Scott Horsley
Water Resources Consultant
65 Little Road • Cotuit, MA 02635 • 508-364-7818

November 4, 2024

RE: Thorndike Place

Figure 1 - Groundwater Mounding at Stormwater Infiltration System (Steady-State Conditions)

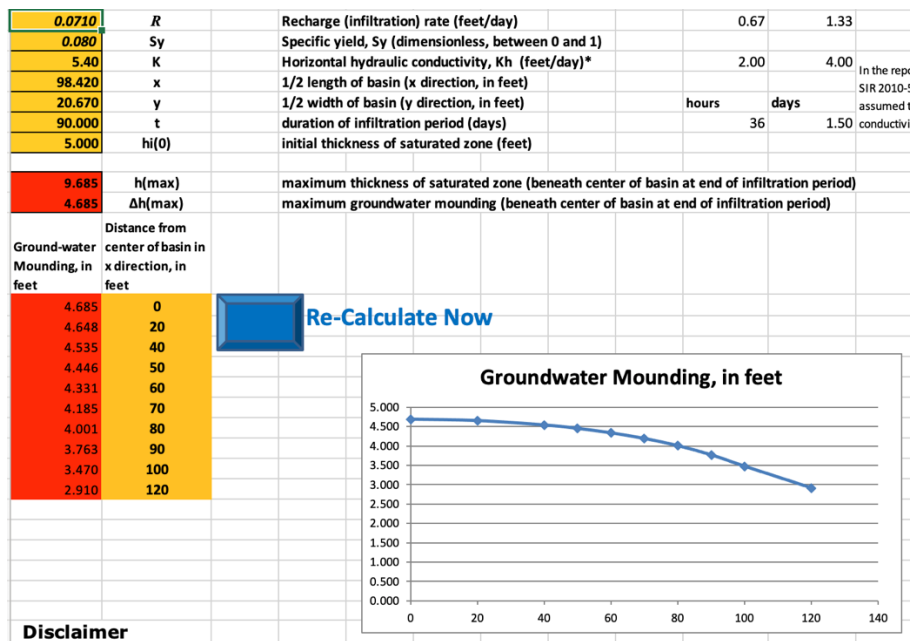
The revised plans prepared by BSC eliminate the previously proposed infiltration systems along Dorothy Road and now concentrate the stormwater infiltration into one location (INF-1). This exacerbates the groundwater mounding impacts. I have prepared an updated groundwater mounding analysis which shows that the proposed infiltration system will be inundated with groundwater and unable to function as proposed and will raise groundwater levels in the adjacent wetland.

To evaluate the impacts of this concentrated infiltration system I have prepared an updated groundwater mounding analysis to determine the cumulative impacts of smaller storms throughout a 90-day period¹. I have utilized the input data for hydraulic conductivity, specific yield and saturated thickness directly from BSC's Response to GZA Peer Review dated October 4, 2024 (Attachment E). I have applied a cumulative runoff rate of 40 inches/year (or 10 inches for the 90-day period)². This analysis shows that the proposed infiltration system will be inundated with a groundwater mound of approximately 4.6 feet and will be unable to function as proposed (see Figure 1).

In summary, the post-development groundwater mounding associated with cumulative recharge associated with smaller storms will raise groundwater levels throughout the site. Utilizing the Hantush modeling inputs provided by BSC these conditions will cause water level increases of several feet at the wetland boundary. MADEP commonly applies a guideline of 0.1 feet as a maximum acceptable alteration in wetlands.
